Review of Otay Mesa Drainage Studies

Contract H084445

Task Order No. 16

Figure 9. 100-year Floodplain in the Water Tanks (East) drainage area (Kimley-Horn and Associate, 2007).

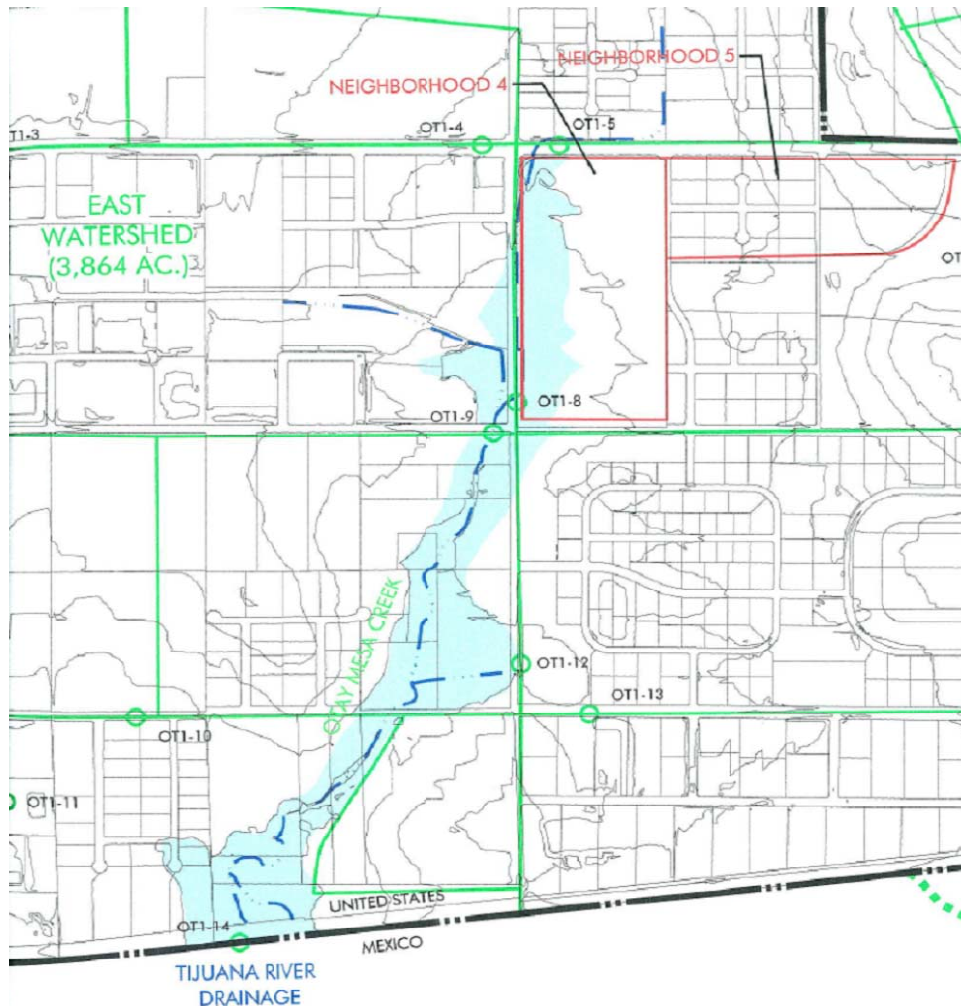
One of the first considerations is who has the responsibility to provide drainage the East Water tanks Drainage Area. The City of San Diego is responsible for public land including runoff from public roads and right of ways. However, as has been pointed out several times in this document, private property owners or developers are required to provide adequate storage and conveyance for 50-year flows in areas in the watershed that are above major (four lane) road crossings (City of San Diego Development Services, 2004). This is typical for most developments in the East Water Tanks drainage area. However, below major roadways, the drainage infrastructure must be designed to accommodate 100-year flows. The 100-year floodplain is also significant in that it is a standard used by the National Flood Insurance Program (NFIP) for floodplain management and to determine the need for flood insurance.

Figure 9 shows 100-year floodplain in the Water Tanks (East) drainage area (Kimley-Horn and Associate, 2007).

The interpretation of drainage language is that all public or private properties are required to provide adequate storage and conveyance for up to the 50-year flows, except for those in the natural drainage channel which are exempt. "Major roadways", that is, those that are four lane or greater and major roadway crossings would require designs that consider conveyance of the 100-year storm either beneath,

along and/or on the roadway as long as not more than one lane of the four is used for conveyance and the conveyance does not encroach onto private property outside of the road right-of-way. None of the areas shown in Figure 9 are considered to be below major roadways.
